RE: INFORMATION REQUEST - EPML00579213 EA AMENDMENT

Peabody Energy Australia PCI (C&M Management) Pty Ltd (Peabody) submitted an amendment to Environmental Authority (EA) EPML00579213 to the administering authority on 16 February 2024. An Assessment Level Decision was made by the administering authority on 16 April 2024, which determined that the proposed amendment was considered a Major Amendment. A Request for Information (RFI) was received from the administering authority on 28 May 2024, with twenty-one information items requested to progress the decision process.

Response to Information
Request for EPML00579213
EA Amendment

EMOS, Figure 2.1 - General Arrangement and Life of Mine Plan.

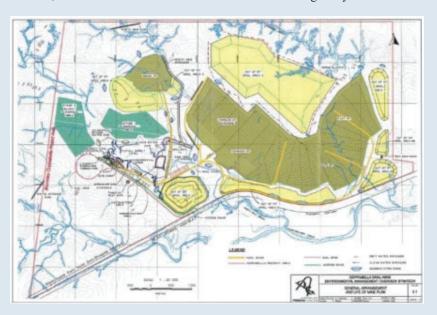
Figure 2.1 – General Arrangement and Life of Mine Plan in the Environmental Management Overview Strategy (EMOS), June 2002, does not include disturbance to land in the Humbug Gully Creek area.

Provide justification demonstrating why land use within ML70164, ML70161 and ML70237 has been determined to be permitted without further Commonwealth Government or Queensland State Government approval.

Clarify what documents are being relied upon to demonstrate a preapproved impact to the Humbug Gully area.

The statement in the EA supporting document is incorrect in its reference to ML 70237. The correct reference is ML 70163, and the response below has been prepared on that basis.

ML 70236 was granted following the assessment of both the February and December 2000 EMOS. As per Figure 2 of the February 2000 EMOS and Figure 7 of the December 2000 EMOS, the assessment considered impacts including vegetation clearing and open-cut mining up to the southern boundary of the Humbug Gully within ML70236.

Figure 1 – Proposed disturbance (as part of original EA application)

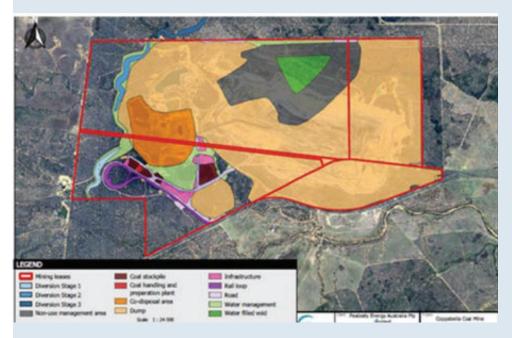
The EA amendment application supporting information document and technical appendices have provided limited information about the area of land that will be disturbed by the proposed amendment.

The EA amendment application supporting information document provides Figure 1 – *Proposed disturbance*, which depicts the domains of disturbance.

However, according to Table C1 – Final land use and rehabilitation approval schedule in the current EA, the total authorised disturbance footprint is 2,390 ha. The projective surface area (ha) for undisturbed land is 1,753 ha, which is approximately 42 % of the total area. The proposed disturbance depicted in Figure 1 appears to be of a larger area than authorised in the EA.

Provide the area (ha) of all proposed land disturbance associated with the amendment (on all the mining leases to which EPML00579213 relates) including:

Provide an updated disturbance map for the EA.

An updated disturbance map and spatial data has been prepared to reflect the proposed land disturbance associated with the amendment and is provided as part of this response.

Figure 1 - Disturbance Area

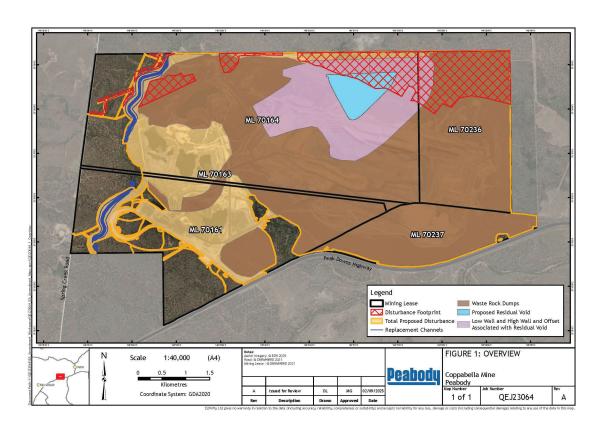
The disturbance areas shown in the Table are incomplete; for example, they do not include high walls and low walls surrounding the 'water filled voids'. Additionally, the total area listed in the table exceeds the current combined area of the Mining Leases by approximately 400ha. This is because ML70161 was originally much larger, extending to the Peak Downs Highway across its width, and its size was never reduced in the Table.

Figure 1 – Proposed disturbance (as part of original EA application)

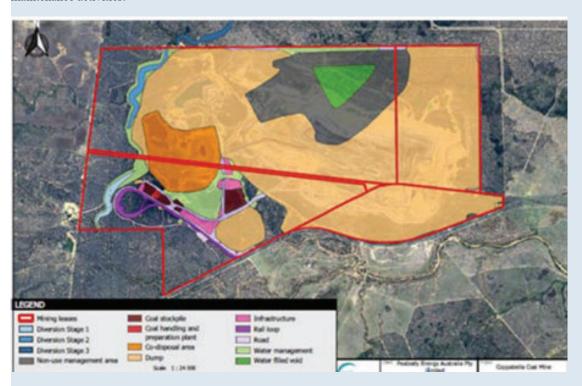
Figure 1 – Proposed disturbance depicts the overburden dump location as adjacent to the eastern mining lease boundaries on ML70236 and the southern mining lease boundary on ML70237, which is adjacent to the Peak Downs Highway. This could hinder future landform re-structuring, shaping or battering, rehabilitation and maintenance activities.

Provide the minimum distance that will be maintained between the overburden dump and mining lease boundaries.

Figure 6 - Protected Wildlife Habitat

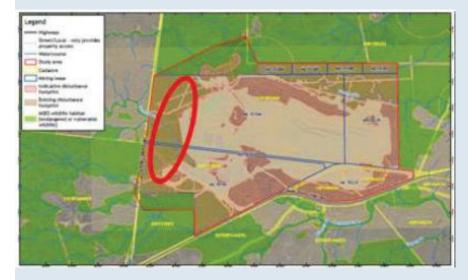
Figure 3 – MSES Vegetation, Appendix H, Desktop Assessment for Prescribed Environmental Matters at Coppabella Mine, submitted with the EA amendment application depicts MSES vegetation on ML70161 in the proposed location of the creek diversion and associated water management landforms. Figure 6 – Protected Wildlife Habitat and Figure 9 – Category B Remnant Vegetation within a Prescribed Distance of a Watercourse in the same document also depict MSES wildlife habitat and Category B Remnant Vegetation within a Prescribed Distance of a Watercourse on ML70161 and ML70164 in the proposed location of the creek diversion and associated water management landforms.

Provide details in regard to the relative risks and likely magnitude of impacts on environmental values in the location of the Humbug Gully Creek diversion.

To address these legacy issues, Peabody has initiated works to replace the existing diversions with modern fit-forpurpose designs, in accordance with the Detailed Design Report – Coppabella Diversions Design (Alluvium, 2023). The works include:

- Southern Replacement Channel construction of a 1.8 km diversion with 1:4 slopes from Thirty Mile
  Creek to Harrybrandt Creek. This channel will remove the need for ongoing remedial works to the
  existing diversion culverts and resolve stability issues.
- Northern Replacement Channel construction of a 2.3 km diversion with 1:4 slopes, along with upgrades to the Peak Downs Highway and rail culverts to accommodate anticipated higher flows. This channel addresses the legacy instability of the existing North Arm Diversion and improves water management for critical transport infrastructure.

**Figure 11 - Transect Locations**

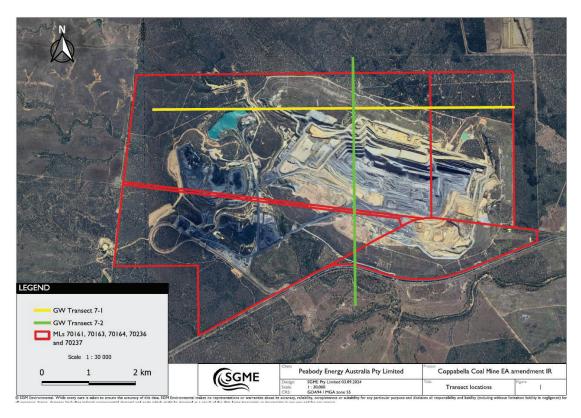
It is difficult to reconcile some of the differences between these figures, perhaps because of the alignment of the sections.

In Figure 7-1 the current topography appears to be about 40 m above the top of MB5.

In Figure 7-2 the current topography appears to be below the bottom of MB5.

Additionally in Figure 7-2 the current topography appears to be down to the coal seam in the area south of MB5, but this existing deep cut area will not be part of the final void or backfilled. These items are confusing to interpret.

Provide a map to show the location of the cross sections. Review the validity of the information provided in Figure 7-1 and 7-2.

A map showing the locations of the cross sections in Figures 7-1 and 7-2 (SLR 2024a) has been produced (Figure 11) and is shown below:

The West-East transect (Figure 7-1) intersects the overburden stockpile located to the north of the current void. This is reflected in the profile peaks of approximately 290 m AHD at around 4000 m from the western transect origin. The South-North transect (Figure 7-2) intersects the current void, which is evidenced in the profile depression of approximately 60 m AHD at around 3000 m from the southern transect origin. The review confirms that the profiles depicted in Figures 7-1 and 7-2 accurately represent the existing landform and mining features. The reason for the difference in topography in Figure 7-1 is because the current topography being an OOPD is above the location of MB55 at the time of installation. The reason for the difference in Figure 7-2 is that the current topography being in the pit shell is below the level of the base of MB-5 at the time of installation.

Figure 1 – Proposed disturbance

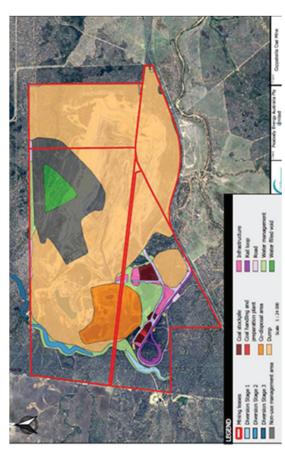
The EA amendment application supporting information document provides Figure 1 – *Proposed disturbance*, which depicts the domains of disturbance.

However, according to Table C1 – *Final land use and rehabilitation approval schedule* in the current EA, the total authorised disturbance footprint is 2,390ha. The projective surface area (ha) for undisturbed land is 1,753ha, which is approximately 42% of the total area. The proposed disturbance depicted in Figure 1 appears to be of a larger area than authorised in the EA.

Figure 3 – MSES Vegetation

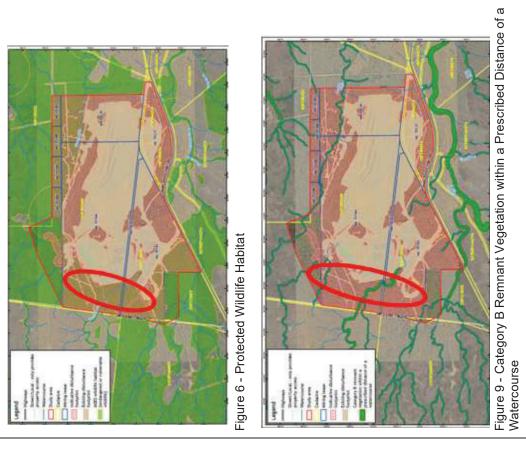
Figure 3 – *MSES Vegetation*, Appendix H, Desktop Assessment for Prescribed Environmental Matters at Coppabella Mine, submitted with the EA amendment application depicts MSES vegetation on ML70161 in the proposed location of the creek diversion and associated water management landforms. Figure 6 – *Protected Wildlife Habitat* and Figure 9 – *Category B Remnant Vegetation within a Prescribed Distance of a Watercourse* in the same document also depict MSES wildlife habitat and Category B Remnant Vegetation within a Prescribed Distance of a Watercourse on ML70161 and ML70164 in the proposed location of the creek diversion and associated water management landforms.

A description of impacts from the proposed amendment on the environmental values of land in the location of the Humbug Gully Creek diversion was not provided in the amendment application.
